UNITED STATES PATENT AND TRADEMARK OFFICE

APPLICATION NO.	FILING DATE	FIRST NAMED INVENTOR	ATTORNEY DOCKET NO.	CONFIRMATION NO.
10/709,874	06/02/2004	Michael Zimmermann	LVIP113US	3873
24041	7590	10/30/2006	EXAMINER	
SIMPSON & SIMPSON, PLLC 5555 MAIN STREET WILLIAMSVILLE, NY 14221-5406			MICHALSKI, SEAN M	
			ART UNIT	PAPER NUMBER
			3724

Office Action Summary	Application No.		Applicant(s)	
	10/709,874		ZIMMERMANN ET AL.	
	Examiner		Art Unit	
	Sean M. Michalski		3724

DETAILED ACTION

Figure 1

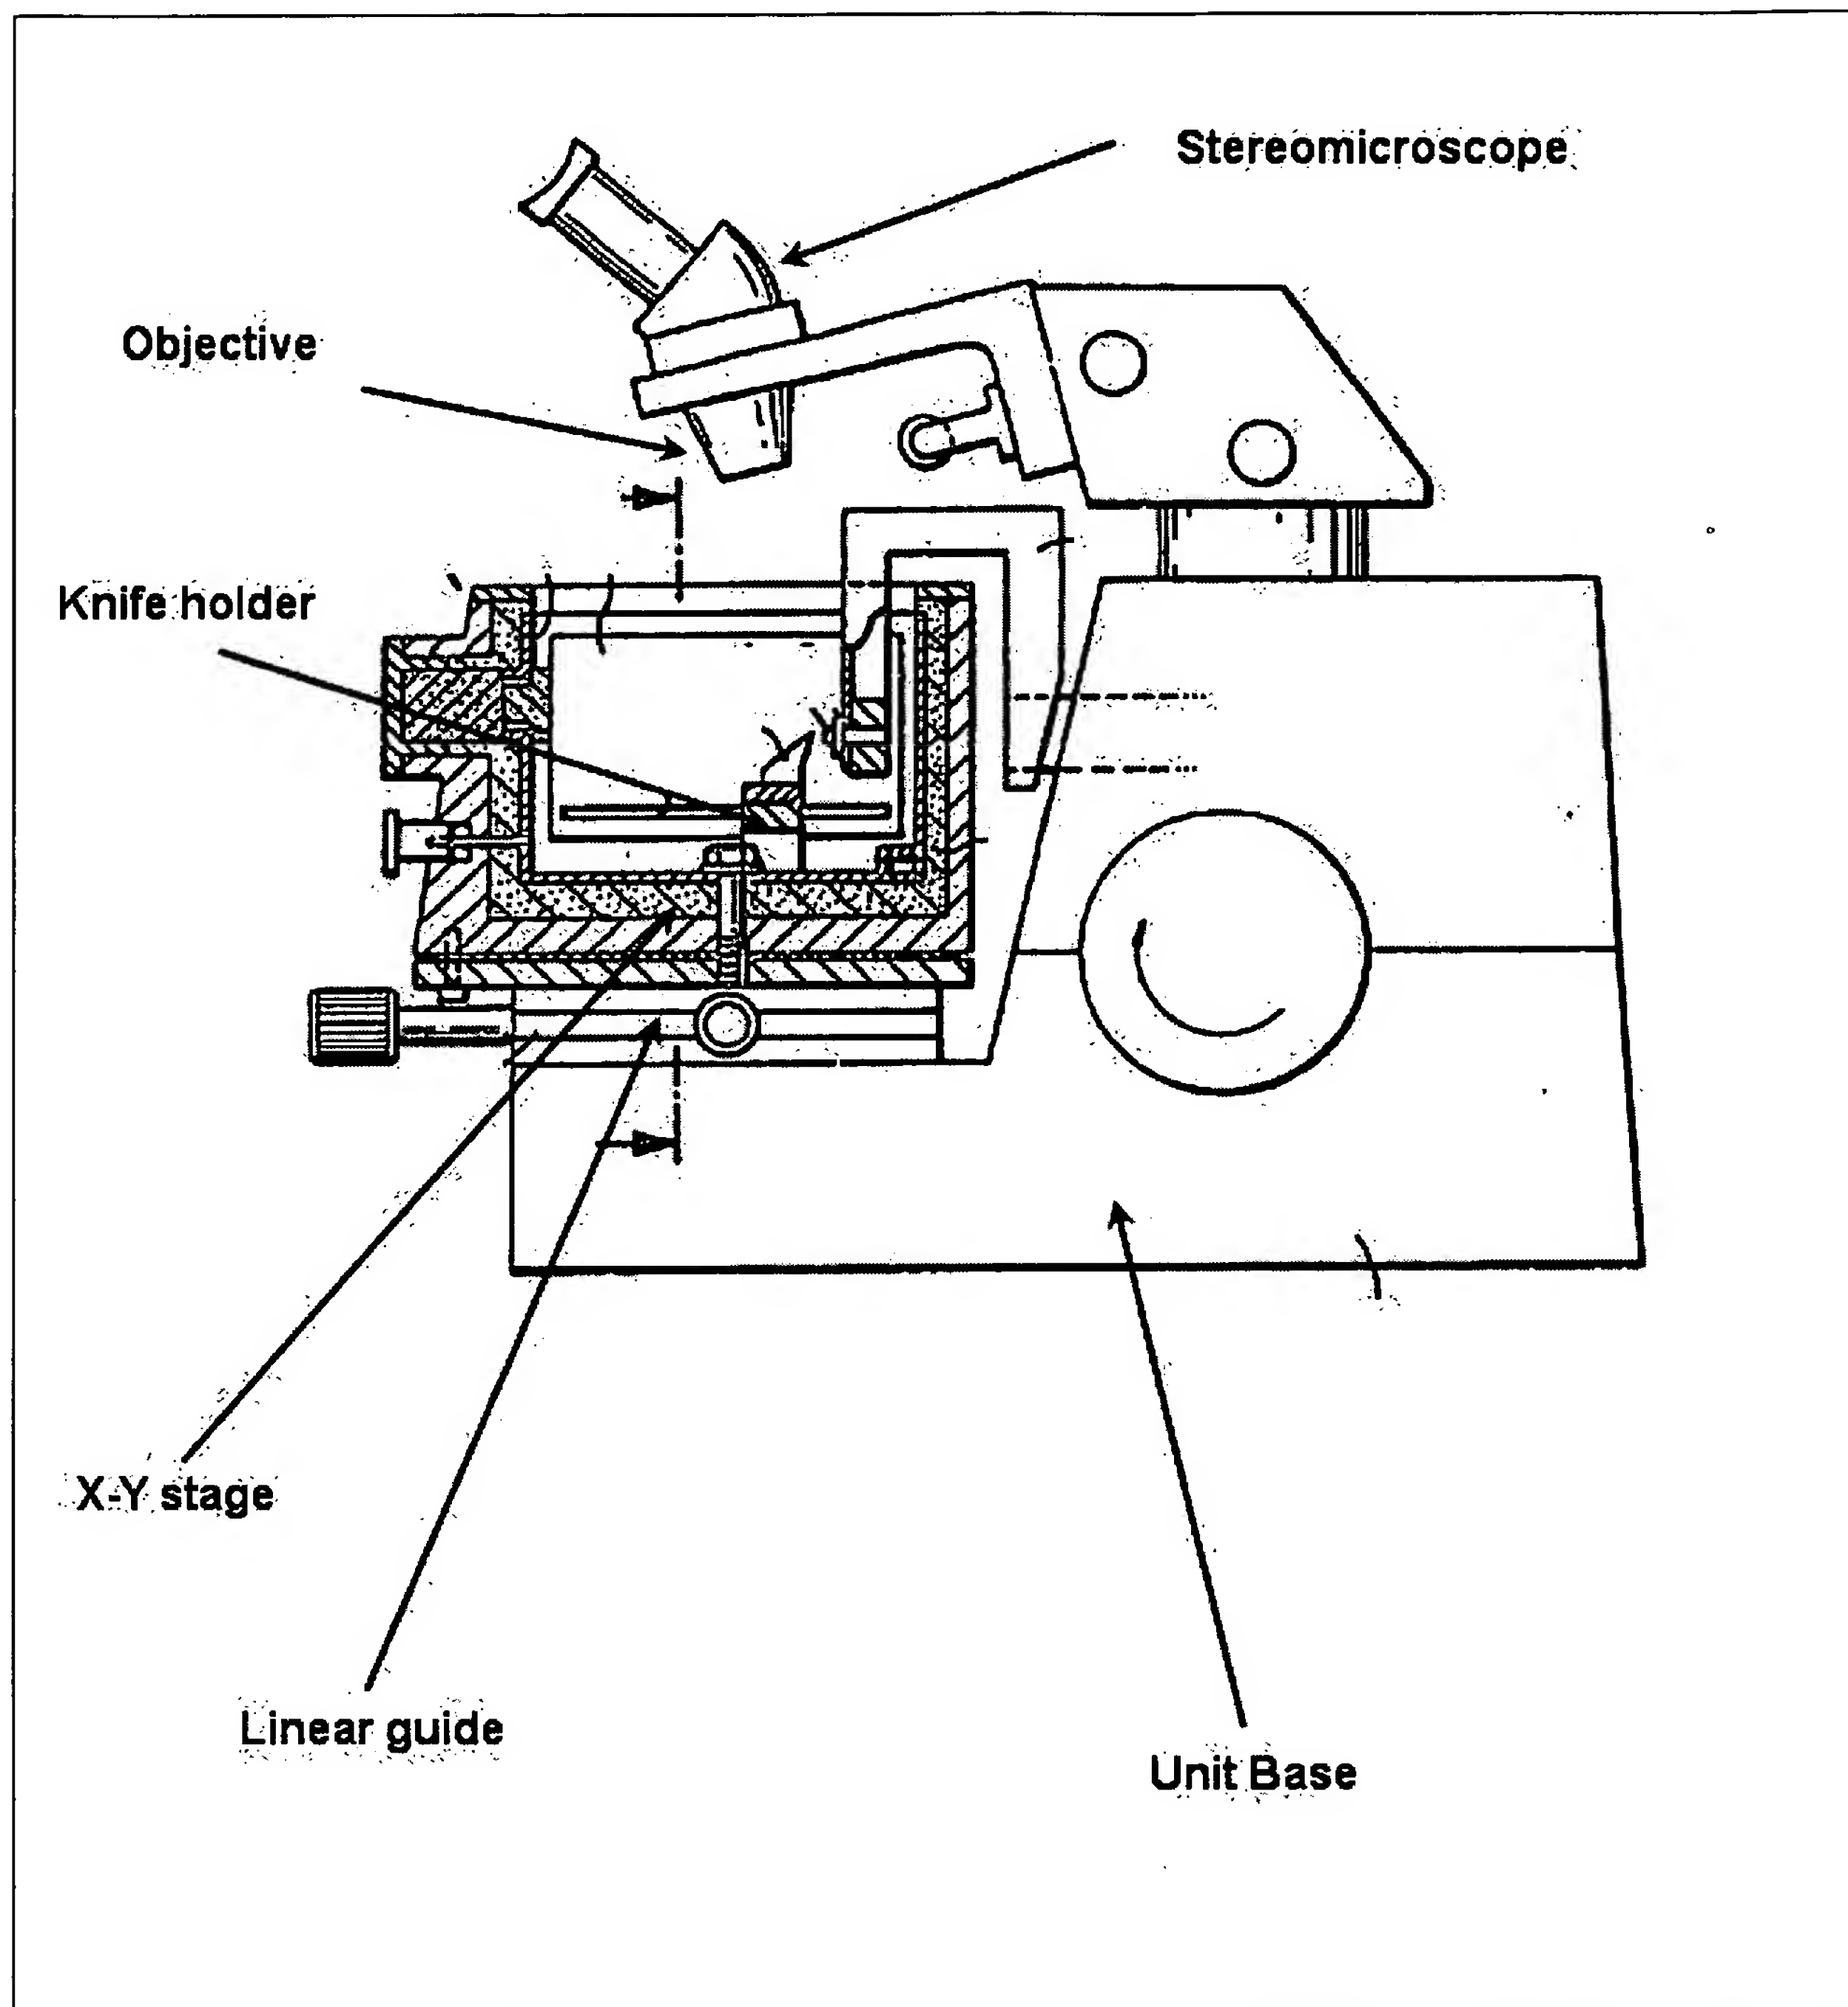
Regarding claim 1 see figure below:

The linear guide guides the displacement linearly. There are multiple milled surfaces on the base that are capable of mounting with the linear guide.

Figure 2

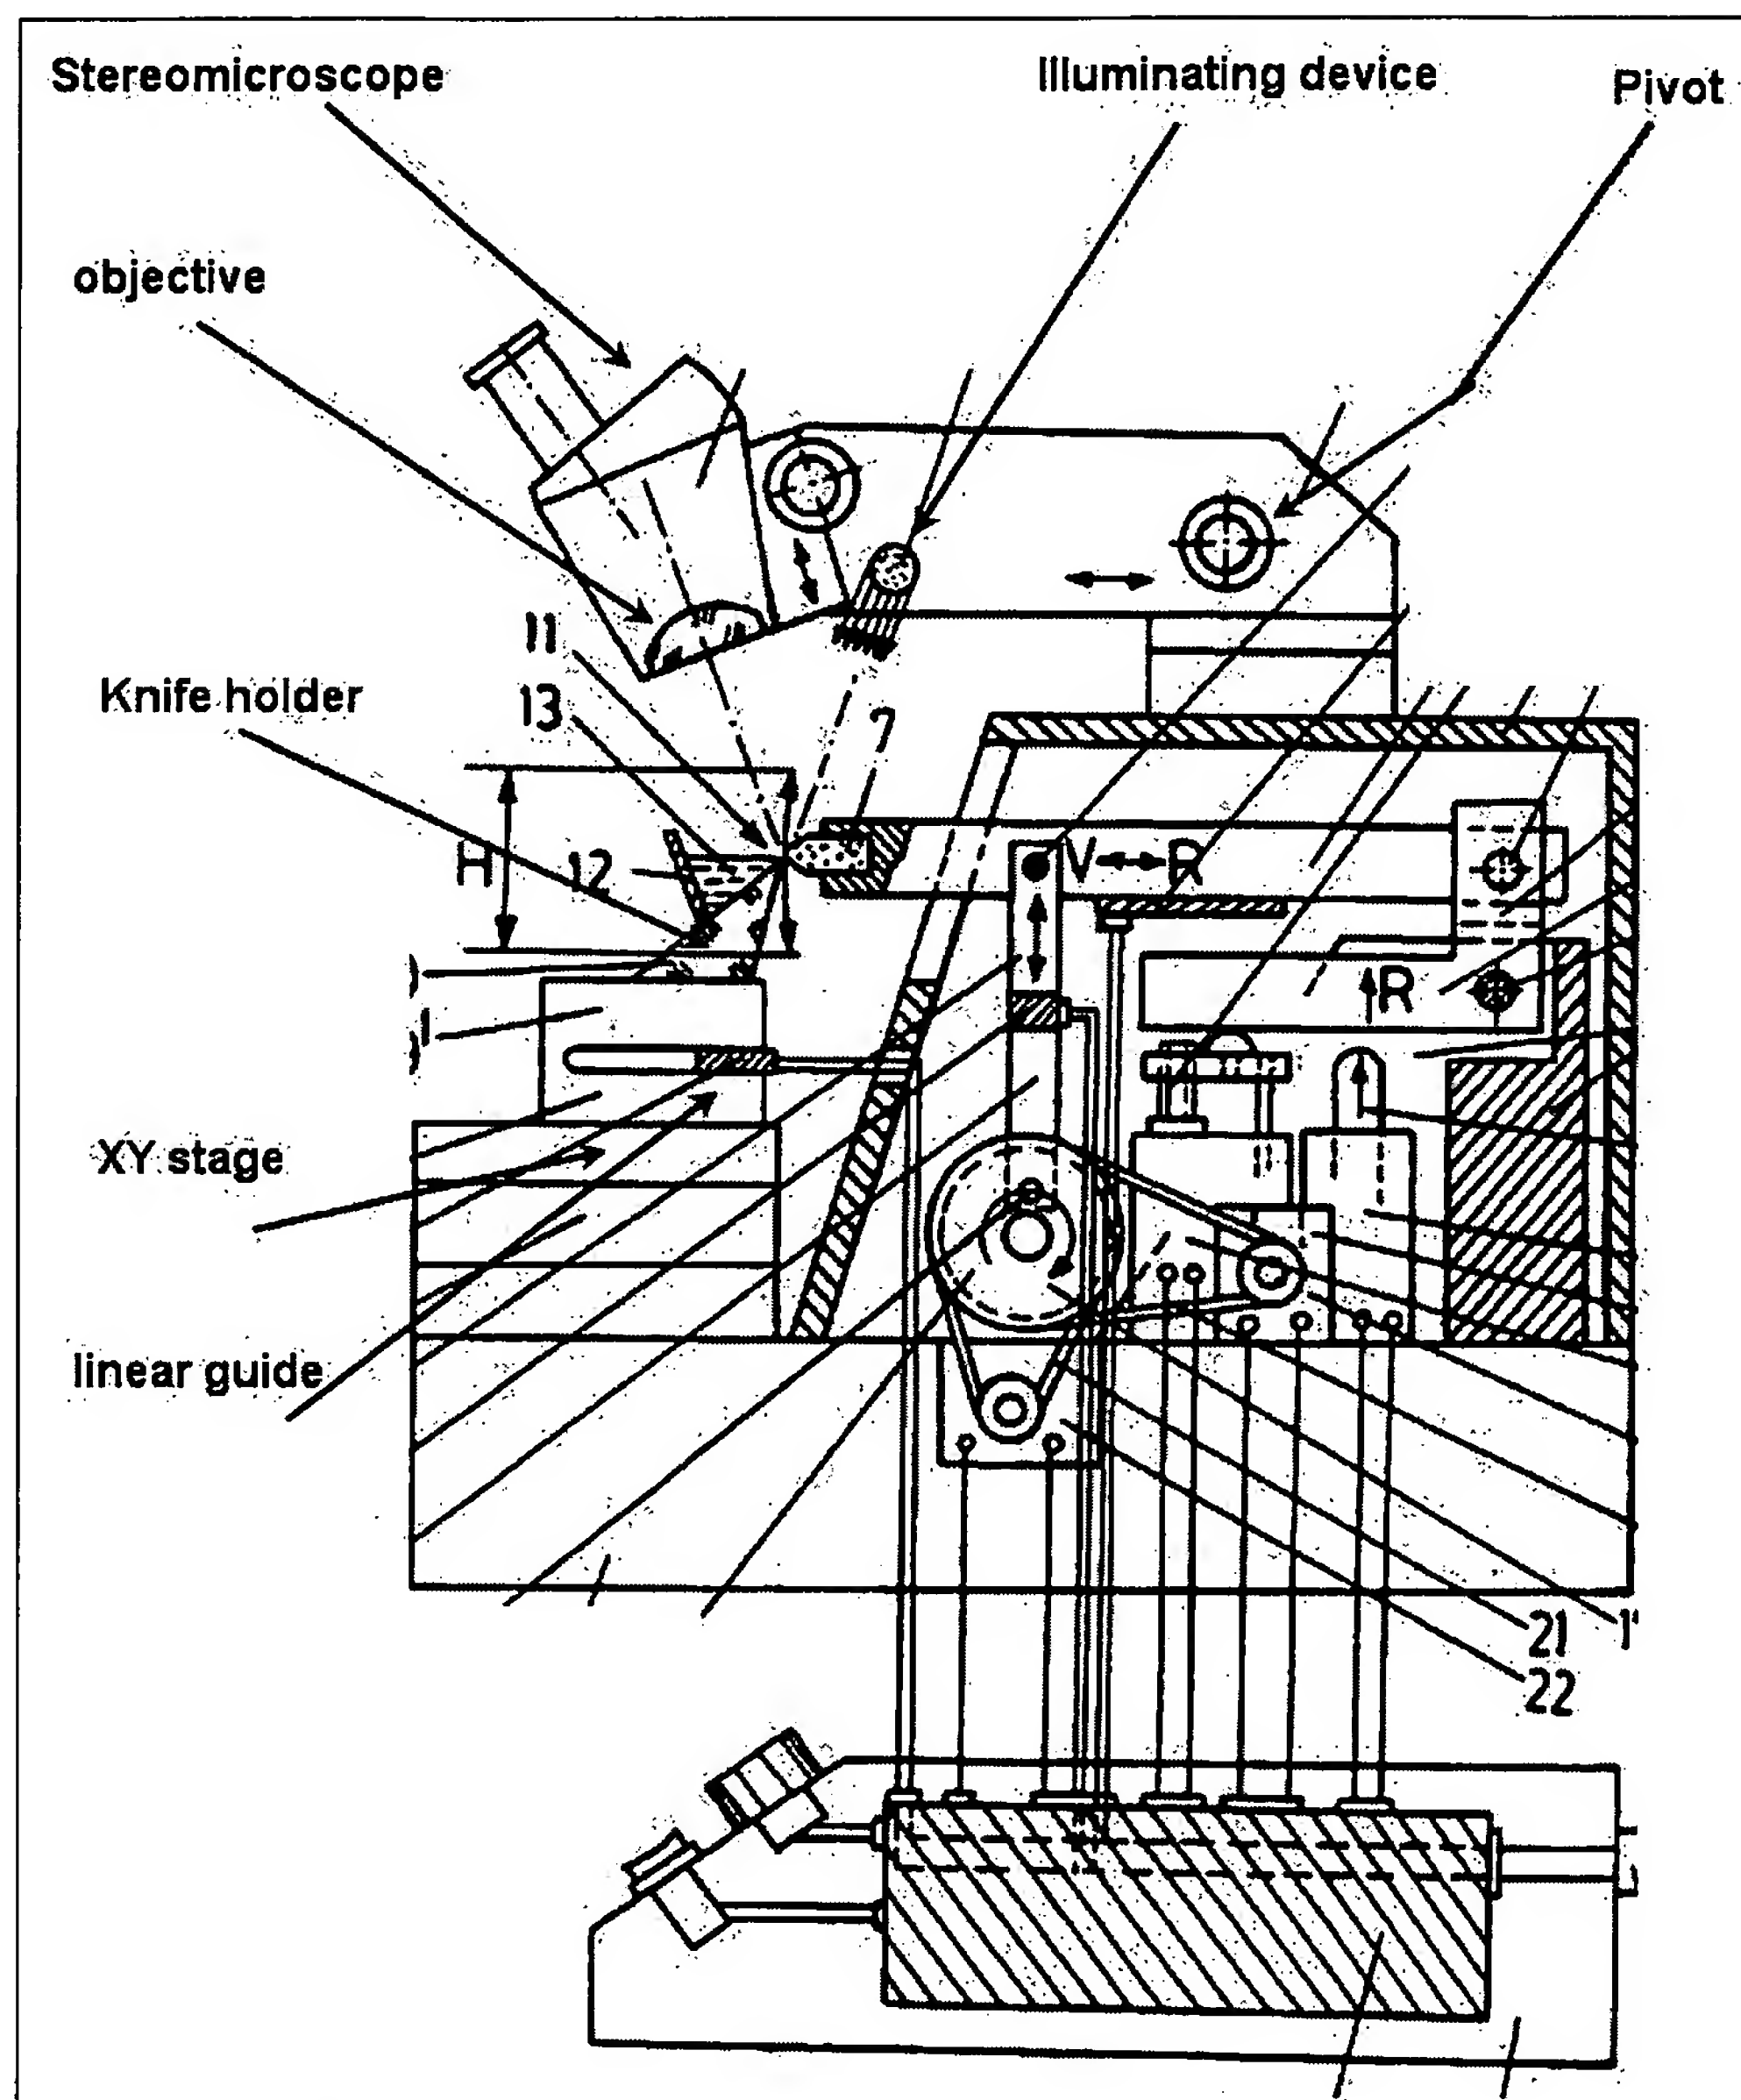
Regarding claim 1, see figure below:

Although only disclosed as Kreuzsupport, the X-Y stage is properly characterized. An internet (google) picture search revealed *only* x-y stages when

'Kreuzsupport' was the sole search term. See attached record of that search. There are seen in the figure a plurality of mounting surfaces for the linear guide, milled in the base.

Regarding claim 4, as seen in figure 2 above, when the observation device pivots about the indicated joint pivot, the illumination device will pivot therewith.
